SERVICE INFORMATION

LAND-ROVER PETROL AND DIESEL MODELS

Vol. 1 No. 10

December, 1972

Fig. 1 Inlet manifold butterfly valve

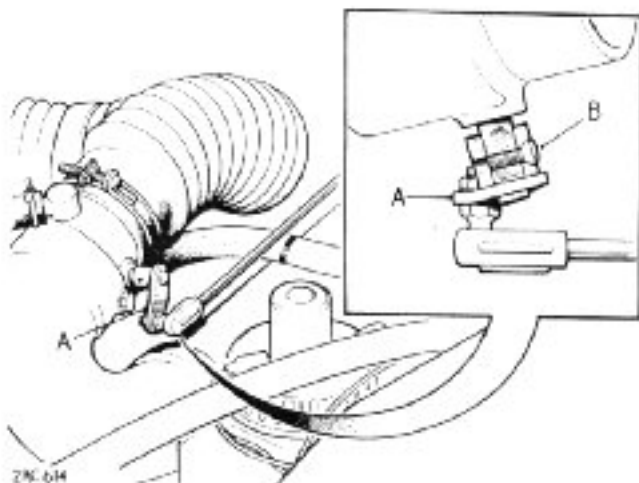
A small number of cases have been reported where the clamp screw, which locks the operating lever to the butterfly valve, has come loose.

If this condition is present on a vehicle, it can cause either a loss of vacuum or excessive smoke to be emitted from the exhaust. Should Distributor or Dealer personnel come across this problem they are advised to first check the positioning and tightness of the clamp screw. If the component is found to be loose it is recommended 'Studlock' or 'Loctite' is applied and the screw re-tightened.

Production Department, as an interim measure, from April, 1972, have been applying 'Studlock' on the screw. To overcome this possible condition permanently, however, it is anticipated that a re-design of the particular area concerned will be carried out.

Fig. 2 Distance piece for inner hub bearing

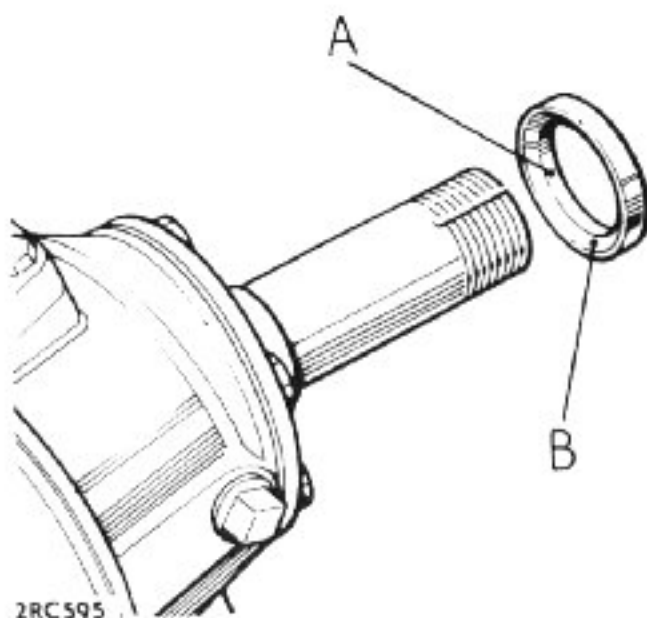
MODIFICATION: Introduction of mild steel distance piece to eliminate oil leaks arising from previous sintered iron type.

A number of Land-Rover owners have experienced hub oil leaks which, in most cases, may be attributed to the sintered iron type inner bearing distance piece, Part No. 217351. This may be subject to splitting in service and cases of porosity have been reported, believed to be due to surface cracking.

NOTE: Because of the material change the mild steel distance piece cannot be removed in the same way as the sintered iron type.

Where hub oil leaks are due to this condition the inner bearing distance piece can be removed as described in the appropriate manual operation listed above and replaced with the latest mild steel type, Part No. 599698, ensuring that Bostick 772 is applied liberally to the inner circumference and the tapered surface which faces the back plate.

In this case, it is recommended that, by exercising reasonable care the distance piece can be partially cut through with a sharp chisel to loosen it, when it can be gently prised off.

A—Apply Bostik 772 to inner circumference
 B—Apply Bostik 772 to tapered surface

Fig. 3 Windscreen pivot arm fixings

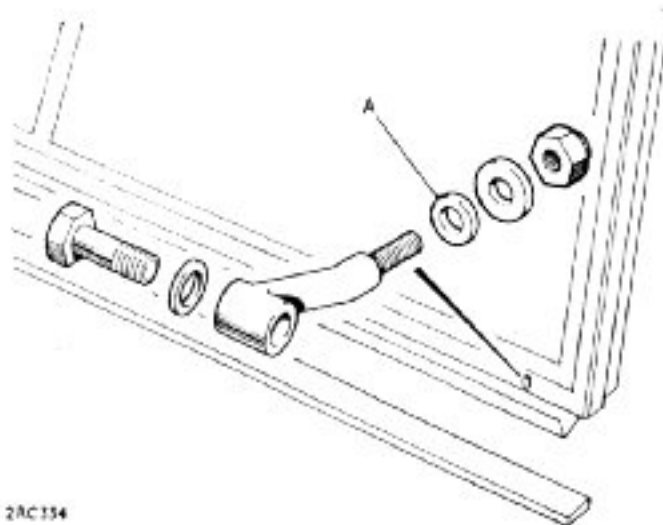
MODIFICATION: Change of washer material.

REMARKS: In certain instances the fibre washer between the windscreen and the pivot arm cracks after initial tightening and during service this washer is displaced by vibration, thereby allowing movement between the windscreen assembly and the windscreen pivot arm. The eventual consequences of this condition is a cracked or broken windscreen pivot arm. The fibre washer has now been replaced by a copper washer and this should be used for all replacements.

PART NUMBER: Copper washer for windscreen pivot 2 232038

A—Copper washer
